DEVELOPMENT APPLICATION ASSESSMENT REPORT

Application Number:	DA2019/1510
----------------------------	-------------

Responsible Officer:	Tony Collier
Land to be developed (Address):	Lot 3 DP 1240491, 106 A Wakehurst Parkway ELANORA HEIGHTS NSW 2101
Proposed Development:	Construction of a dwelling house including a swimming pool
Zoning:	E4 Environmental Living
Development Permissible:	Yes
Existing Use Rights:	No
Consent Authority:	Northern Beaches Council
Land and Environment Court Action:	No
Owner:	Barray Civil Pty Ltd
Applicant:	Thodey Design

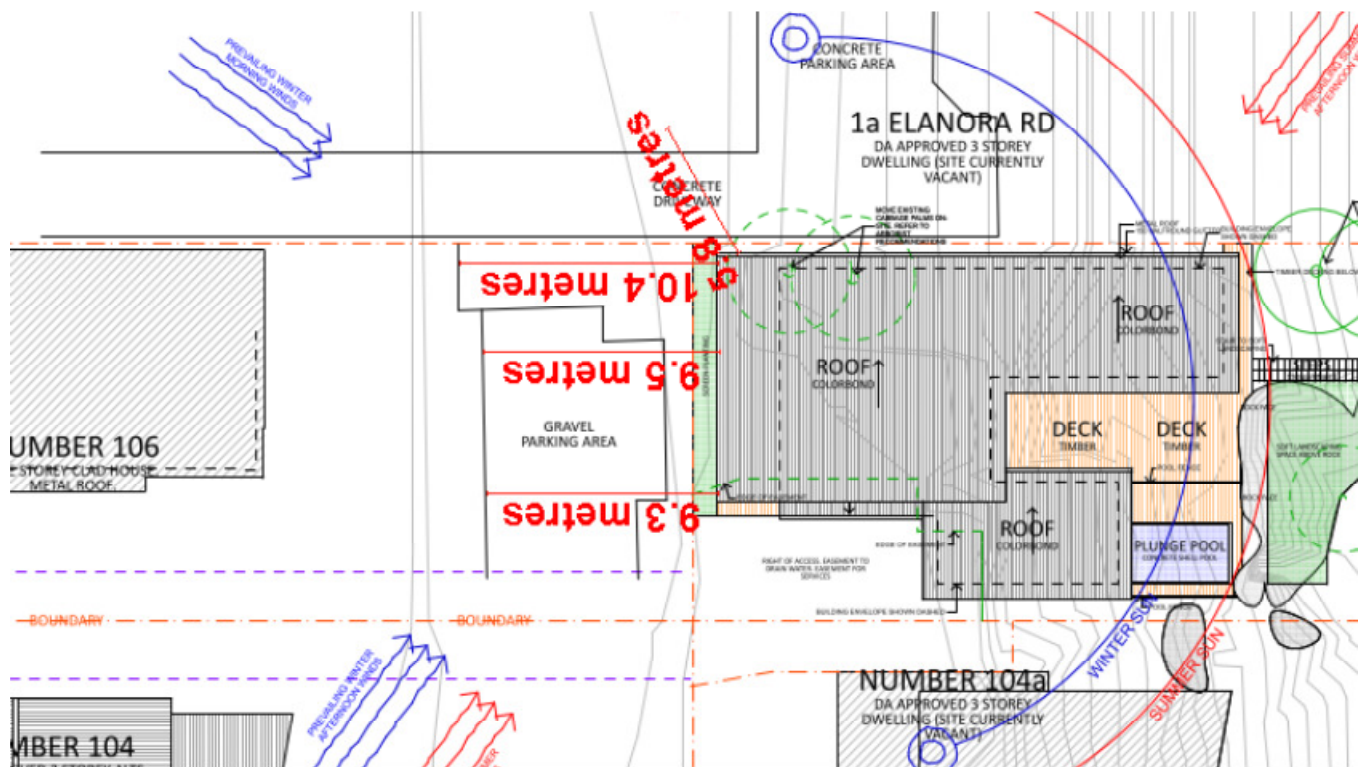
The development includes balconies which are situated at the southern elevation of Levels 1 and 2. The balconies face towards the rear of No. 106 Wakehurst Parkway and are setback 1.0m from the property boundary. Notwithstanding this setback, it is noted that an open parking area associated with 106 Wakehurst Parkway (required as part of the approved subdivision) is located between the property boundary and the fenced private open space area of that property. This effectively creates a separation

of between 9.3m and 10.4m between the proposed balconies and the private open space area of 106 Wakehurst Parkway and therefore, in compliance with the 9.0m separation requirements of Clause C1.5.

The afore-mentioned balconies are also setback approximately 5.0m from the rear private open space area of No. 1 Elanora Road (located to the west). The setback is largely due to the locating of a driveway to service the newly formed rear allotment at No. 1A Elanora Road. The balconies include 1.0m balustrades and are open to the side thereby enabling overlooking into the rear yard. While it is acknowledged that the positioning of the dwelling is due to the constraints of the site and the approved subdivision, this is not compliant with the 9.0m separation requirements of Clause C1.5 and therefore, it is considered appropriate to impose a condition requiring the installation of fixed privacy screens along the western edge of both balconies to mitigate direct overlooking while enabling unobstructed access to the primary view to the south.

The figure below shows the distances to property boundaries and private open space areas of neighbouring properties.

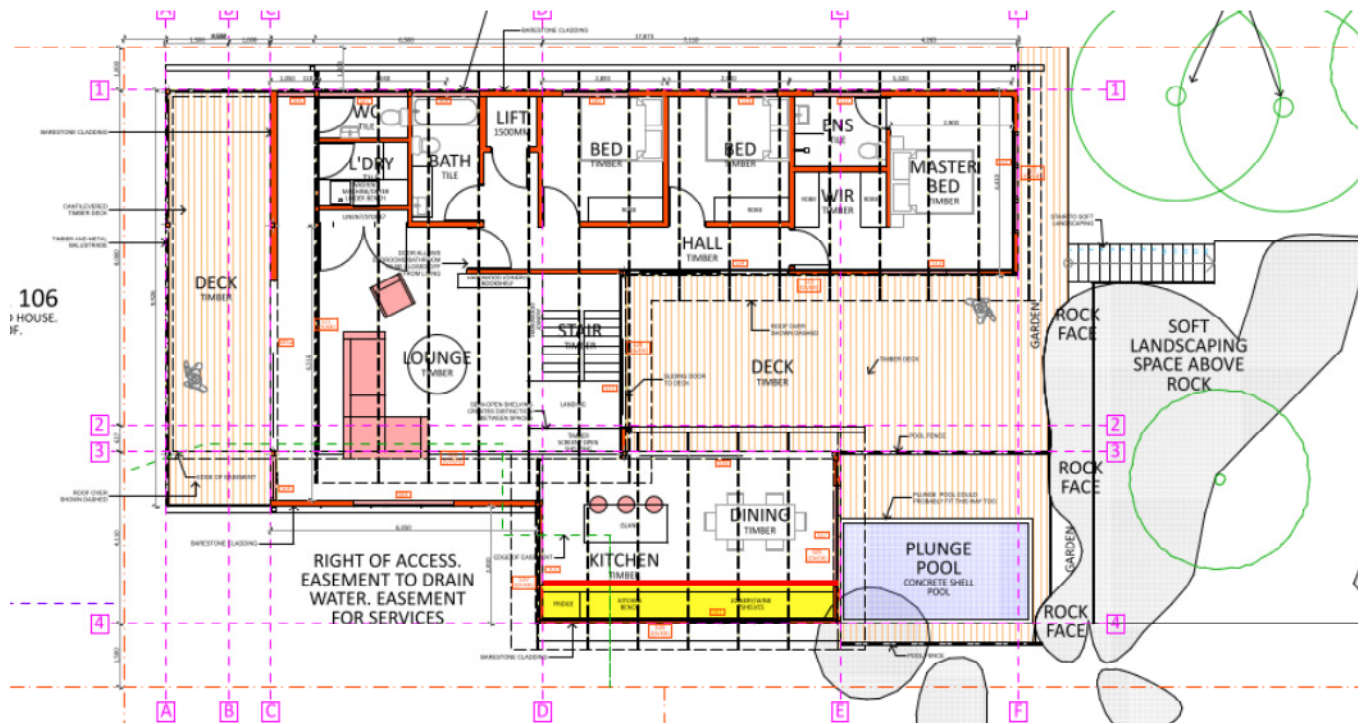
The development proposes an eastern side setback of between 1.5m and 6.0m. The non-compliant element is setback at 1.5m and occurs at Level 2 (kitchen and dining room). This represents a variation of 40% (1.0m). The non-compliant element extends for a wall length of 7.2m and is sited towards the rear of the dwelling.

The figure below shows the area of non-compliance (highlighted in yellow).
